TECHNICAL MEMORANDUM

DATE: April 1, 2009

SUBJECT: Response to IDWR's March 2, 2009 Staff Memorandum
On M3 Eagle Hydrogeologic Studies

Figure 3. Deep Well Locations and Transect Lines for Hydrogeologic Cross-Sections

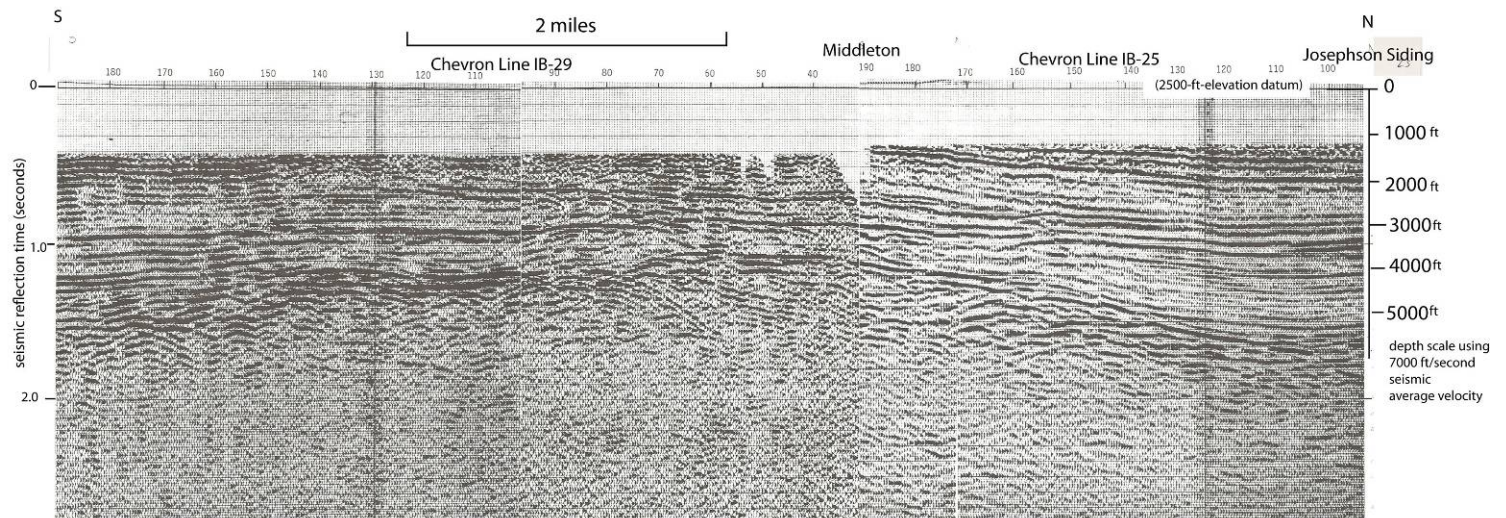
Staff suggests that these sediments may be "faulted." We take up the issue of faulting in more detail below, but note here that, with perhaps one exception, there is no evidence that the major faulting in the deep volcanic basement rocks, including that detected by the magnetometer survey conducted by M3 Eagle in 2007, offsets, or even breaks, the shallower water bearing units including the PGSA. The available evidence actually shows the opposite, that the deep-seated faults do not propagate to land surface or penetrate the younger sediments above, as shown by seismic reflection studies (see Figure 2 of this report and Figure 16 of Wood and Clemens, 2002).

The down-dip cross section showing the base of the PGSA (HLI 2009, Figure 3) shows a maximum SW dip of less than 2½ degrees (200 ft/mile). That dip is typical of depositional dip (Wood, 2004, Figure 9, p. 115) and characteristic of the upper sedimentary section of the western Snake River Plain. Such a dip also is much less than the typical 5 degree dip in the deeper sediments (Squires et al., 1992, p. 25 and Figure 6, p. 83) of the basin. There is no reason to believe that faulting significantly affects the PGSA southwest of and on the M3 Eagle property.

Figure 4. Hydrogeologic Cross Sections based on Deep Exploration Well Borehole Geophysical Analyses (from Wood)

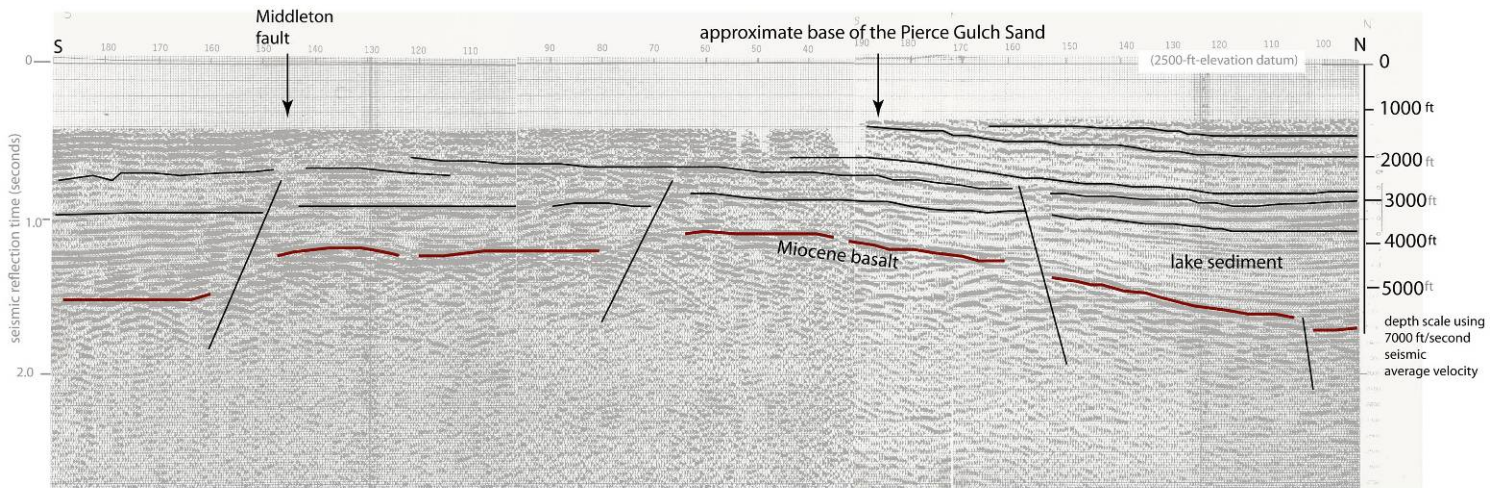
“The stratigraphic and geophysical logs for TW#4 do not show a strong correlation with the depiction of the mudstone unit drawn in the cross-section that runs from TW#3 to the UWID State and Linder well.” Staff Memo at 4.

The deep geophysical logs previously submitted to the Department, and the cross-sectional diagram of Figure 4, show that the lower part of the PGSA to the west-northwest of M3 Eagle lies below the Payette Valley floor. We are aware of no investigation of the shallow ground water system in the Payette Valley. So we withhold judgment on the nature or exact locations of PGSA discharge into the Payette Valley. But again, naming the exact mechanism of PGSA

Figure 5. Comparison of Water Level Responses in TW #1 and TW #4
From Continuous Water Level Monitoring
 Monitored For M3 Eagle By: *Hydro Logic Inc.*

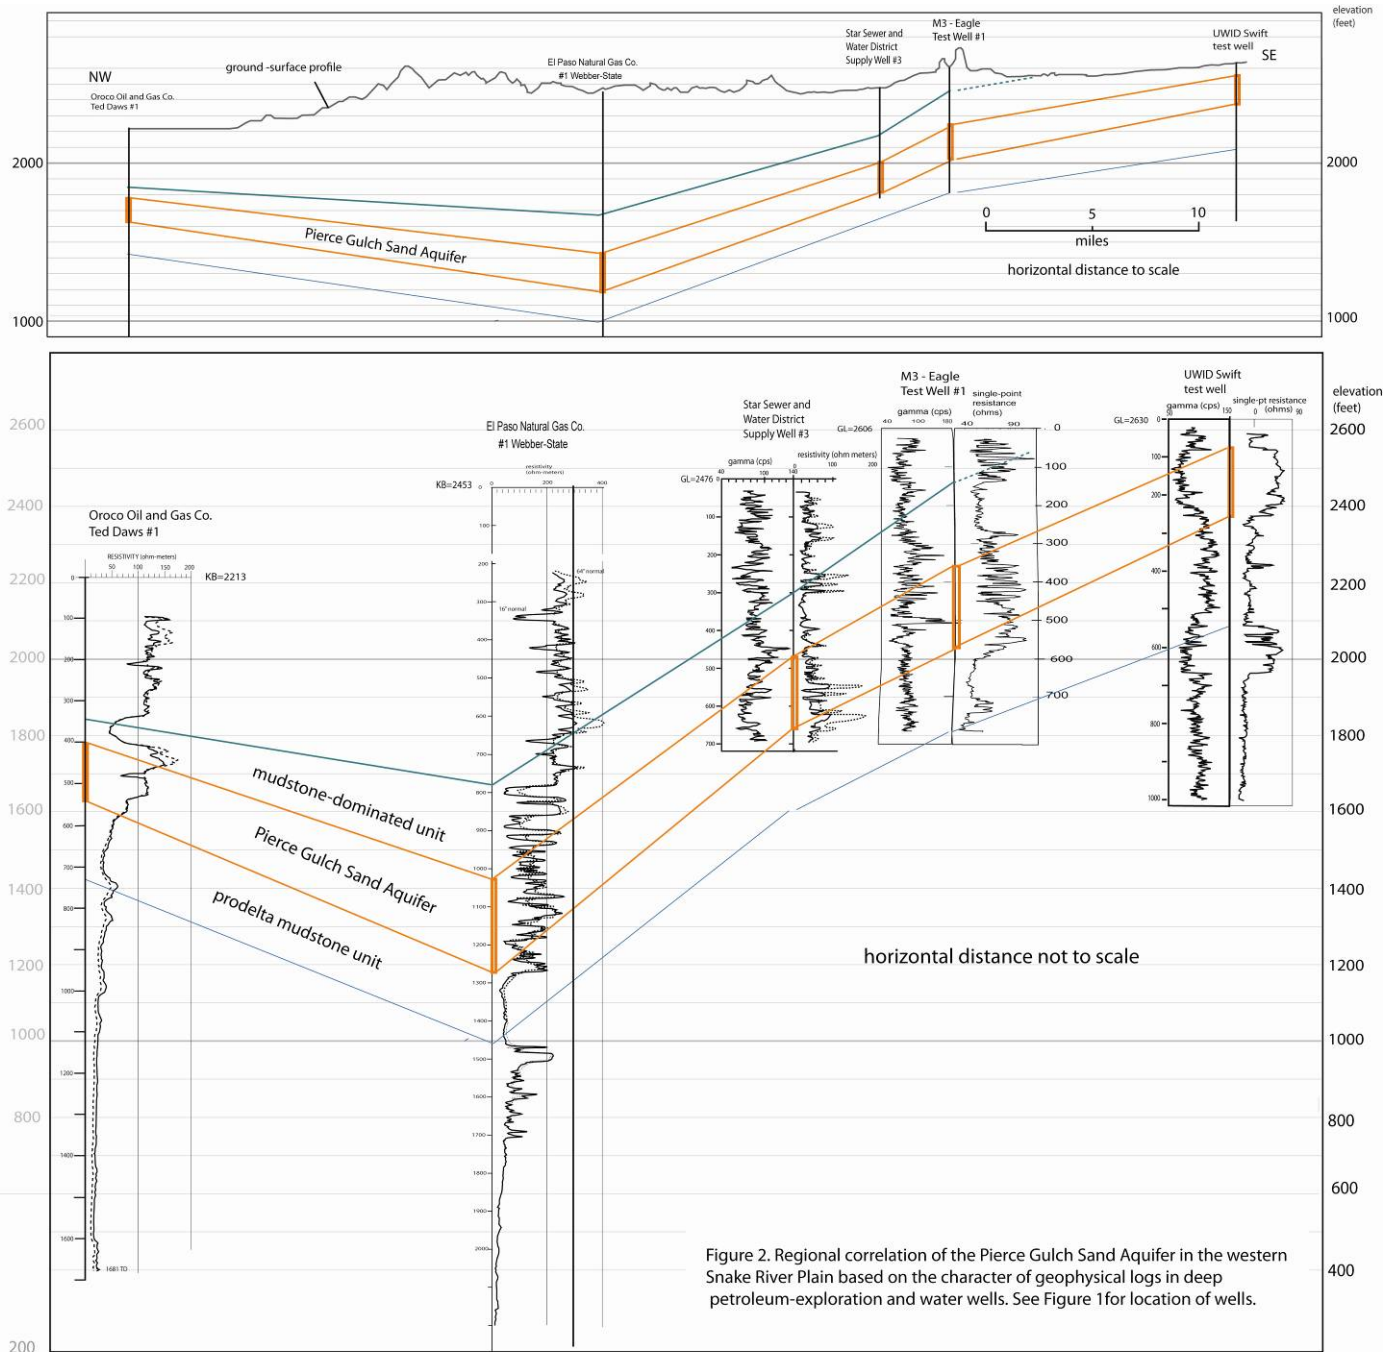
The Staff Memo states that the “cross-section that bisects Big Gulch does not show the fault between TW#1 and TW#4 that was identified in surface geophysical work contracted by HLI (Wood, 2007),” and that “[t]he offset from this fault could account for, at least in part, some of the differences in elevation of the tops and bottoms of the various strata that are represented as uninterrupted. The identification of faults is important for the characterization of the hydrogeology because faults often affect hydraulic communication between hydrostratigraphic units.” Staff Memo at 4.

As further evidence of the lack of a hydraulic boundary, we have included hydrographs showing continuous water level monitoring from M3 Test Wells TW #1 and TW #4, located on opposite sides of the presumed fault (Figure 5). These hydrographs demonstrate that the same hydraulic events are observable on water level plots for both wells. The changes in water levels in TW #4 are smaller and delayed in comparison to those observed in TW #1, as would be expected: TW #4 is closer to the edge of the aquifer where unconfined conditions result in much larger storativity values. Greater storativity can have the effect of delaying and attenuating hydraulic responses in wells.

Also note that the drawdown response to the pumping test of SVR #7 (discussed further below) can be observed in both TW #1 and TW #4 (Figure 5). These similar responses themselves indicate that the deep seated bedrock fault indicated by Wood (2008) does not act as a no-flow boundary as speculated by IDWR staff. Water level contour maps based on field measured data and surveyed well heads included in documents submitted to IDWR (HLI, 2007, 2008a, 23008c) all show ground water in the PGSA flowing to the west and west-northwest beneath the M3 site. Were the fault to act as a hydraulic barrier, ground water flow would be directed toward the north or to the south and not across the presumed no-flow barrier.

Even so, attached to this Memorandum as Figure 5 is a composite hydrograph correlating water levels and hydraulic events across the area Staff evidently believes may be a fault-induced no-flow boundary. This figure shows that the same hydraulic pumping events affect M3 TW-1 and M3 TW-4. These two wells are on opposite sides of the postulated fault/no-flow boundary, and each is a member of a separate Staff-defined well group. The fact that the water level fluctuation between the two wells is “nearly an order of magnitude greater” does not justify Staff’s implication that the two well groups lie in separated geologic units. Such a difference would be expected given the locations of these wells relative to the pumping wells that are causing the seasonal drawdowns and the effects of being closer to the unconfined edge of the aquifer.

The figure also shows that drawdown occurred in both wells during the course of the SVR #7 Aquifer test (discussed below). Although the HLI report on this test indicated that drawdown was too small to be quantitatively analyzed, the attached figure shows that qualitatively, a water level change consistent with the general shape of a drawdown curve can be observed in the TW #1 hydrograph in the figure from pumping of SVR#7. The data show hydraulic communication between these wells—regardless of how they are grouped—not separation and not evidence of a no-flow boundary.

Figure 6. Cooper-Jacob Analysis for the Big Gulch Stock Well with Water-Level Trend Corrections

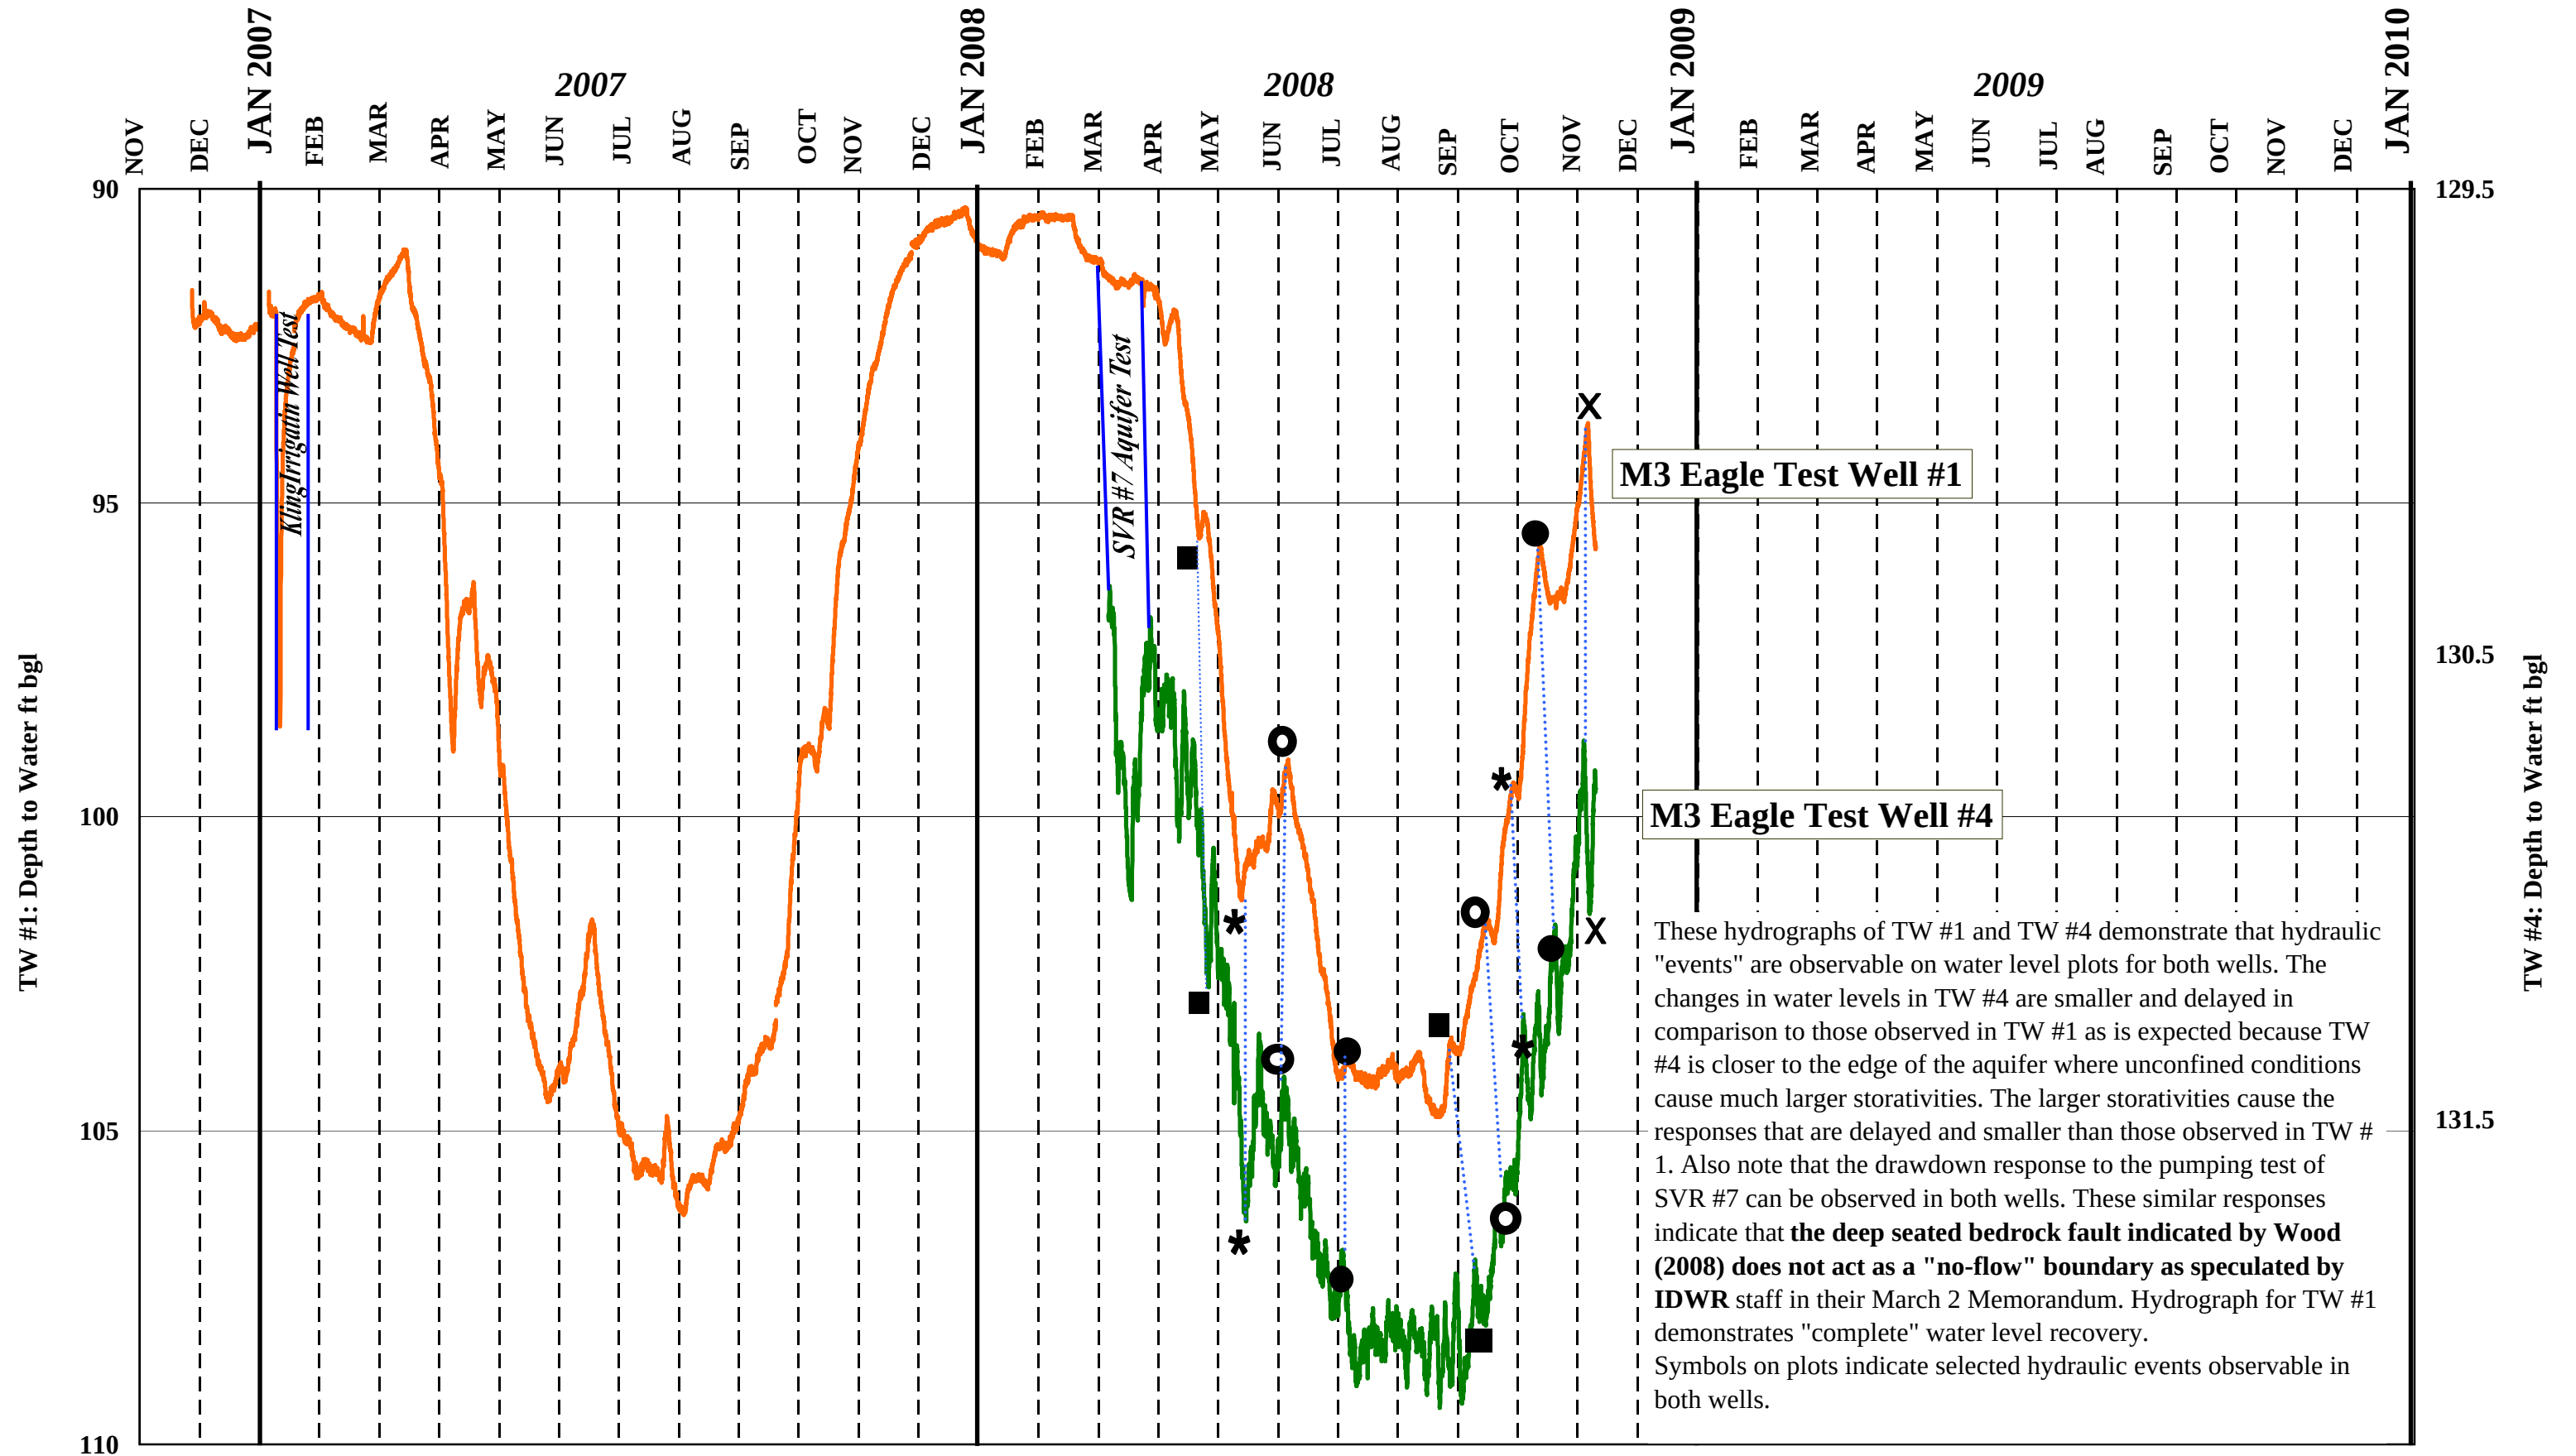
With regard to the SVR#7 aquifer test, the Staff notes "an increase in slope on the semi-logarithmic plot of drawdown versus time for the Big Gulch stock well" about four days into the test (HLI, 2009, Figure 24), and states that "[a]n increase in slope is characteristic of the cone of depression encountering a no flow/barrier boundary (Driscoll, 1986; p. 231 and USBR, 1995, p. 251). HLI instead attributes the slope increase to a declining regional aquifer water level trend, which is a plausible concept. Unfortunately, a plot of trend-corrected drawdown is not presented for the Big Gulch stock well. Our calculations indicate that the regional trend (Figure C2) does not fully account for the increase in slope that was observed on the semi-logarithmic plot for the Big Gulch stock well." Staff Memo at 11.

The water levels in the Big Gulch stock well fully recovered to the annual fluctuation of the regional water level trend. The apparent lack of full recovery in both the pumping well (SVR #7) and the nearby observation well (Big Gulch stock well) is best explained by the seasonal declining water level trend observed in the long-term monitoring data. Figures C-2 and C-4 presented in HLI (2009) and available for staff review show that water levels in this portion of the Pierce Gulch Sand Aquifer were rising during the months of January and February and began to decline just before the start of the test. Linear projection of the water levels measured during late May back toward the time when the water level trend reversed from rising to declining, shows that both well SVR #7 and the Big Gulch stock well recovered to the projected non-pumping water levels during mid-April.

Adjusting the drawdown data from the Big Gulch stock well to correct for this trend (using a linear correction of 0.009869 ft per day, as calculated using a straight-line plot through the mid-April through the end of May water level data and shown in Figure C-4) generated a drawdown plot (Figure 6) with almost all of the apparent end-of-test increase in drawdown removed (as compared with the plot shown in Figure 24 of SVR #7 aquifer test report (HLI 2009) which did

Figure 8. Comparison of Water Level Data Plot on IDWR Website with Analysis of Selected Data by McVay for Well 04N01E 03DAD1

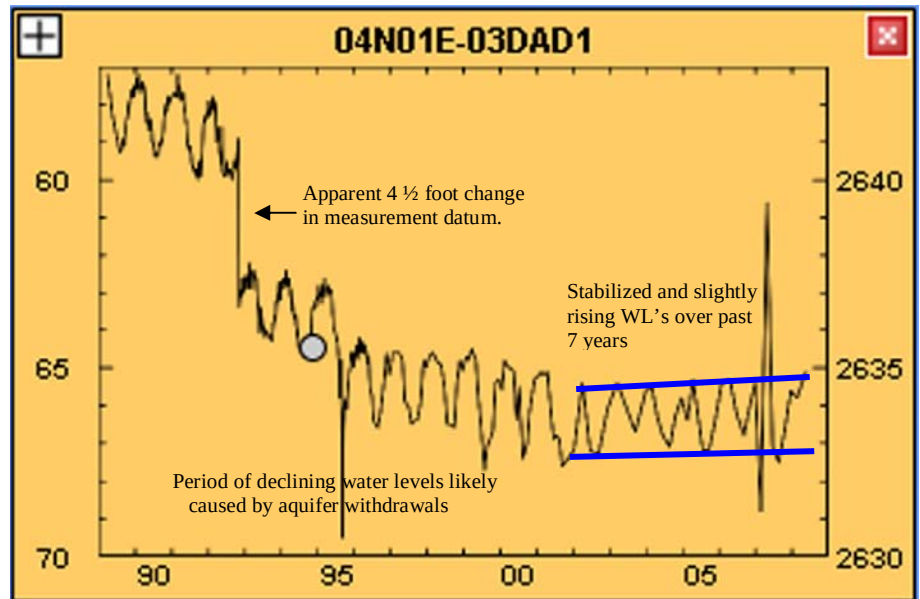
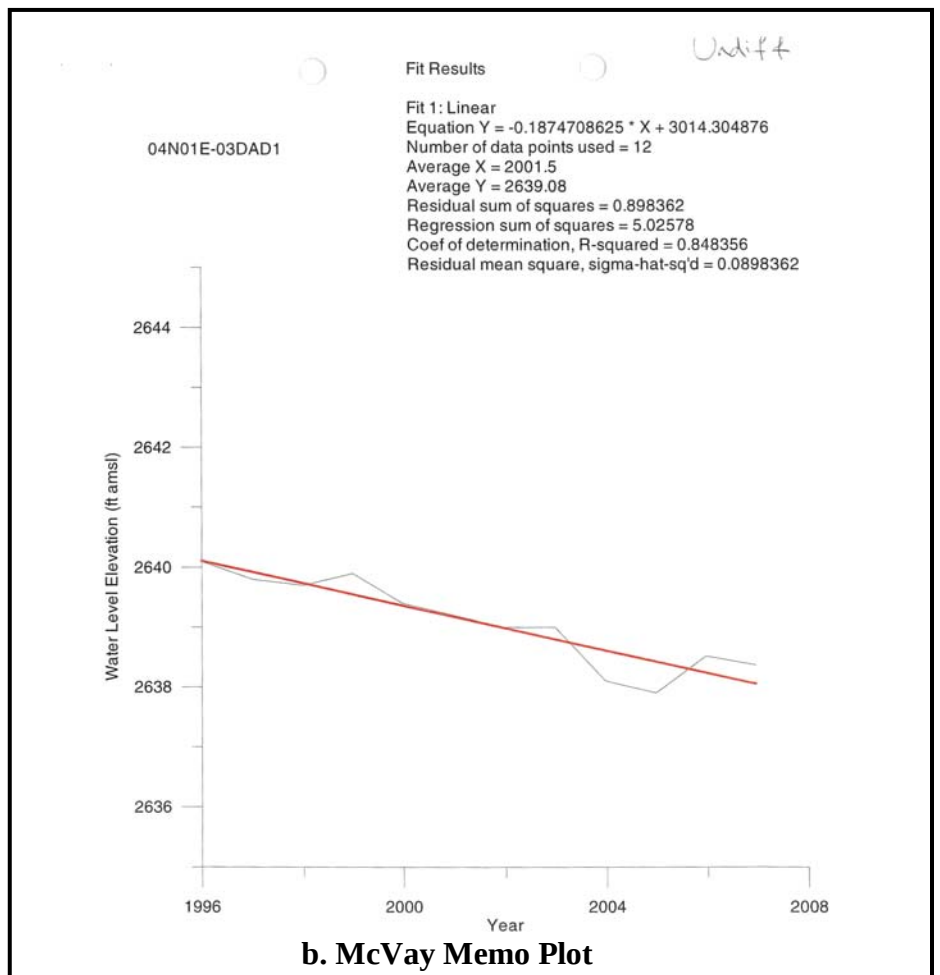
McVay's plot purports to show a steadily declining "non-irrigation season" water level. By ignoring the visual trend apparent in the complete data plot, McVay's analysis combines data from a period of water level decline with a period of water level rises and gives a **false indication of true conditions in the Terteling Springs Formation mudstone aquifer.**

A case in point is Well 4N1E3DAD1, the data points of which are presented on Figure 8. Plotting all available data shows three distinct water level trends. Over the last seven years the well has exhibited a steadily rising trend in both the maximum drawdown level and maximum recovery level. We believe it is incorrect to use this well, and the data from it, to conclude that "water levels near M3 are declining" or that "current aquifer discharge rates exceed current recharge rates." Staff Memo at 20. The fact is that water levels near M3 are rising, and have been for the last seven years (Figure 8).
